Part Number Update

Bulletin No: PNU-252

subject: **Bendix® ACom® Diagnostic Software - Mandatory Update**

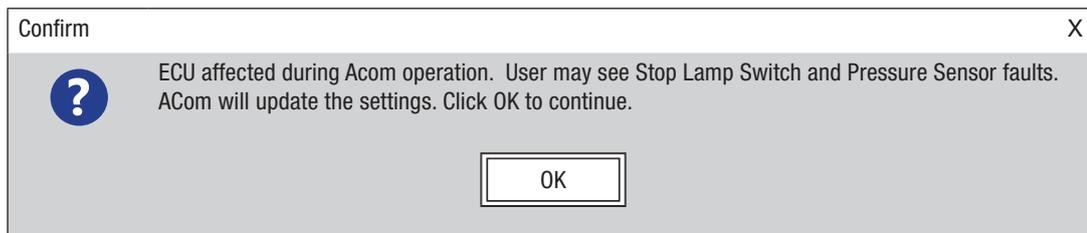
The following confirmation dialog box will be displayed when the new version of ACom diagnostic software (v6.16.5.2 or greater) detects a controller with this condition and repairs it.

If the DTCs shown in the table below were observed and continue to recur after connecting ACom diagnostic software v6.16.5.0 to a Bendix ESP Stability EC-80 ECU, then ACom diagnostic software v6.16.5.2 or greater must be used to clear the DTCs.
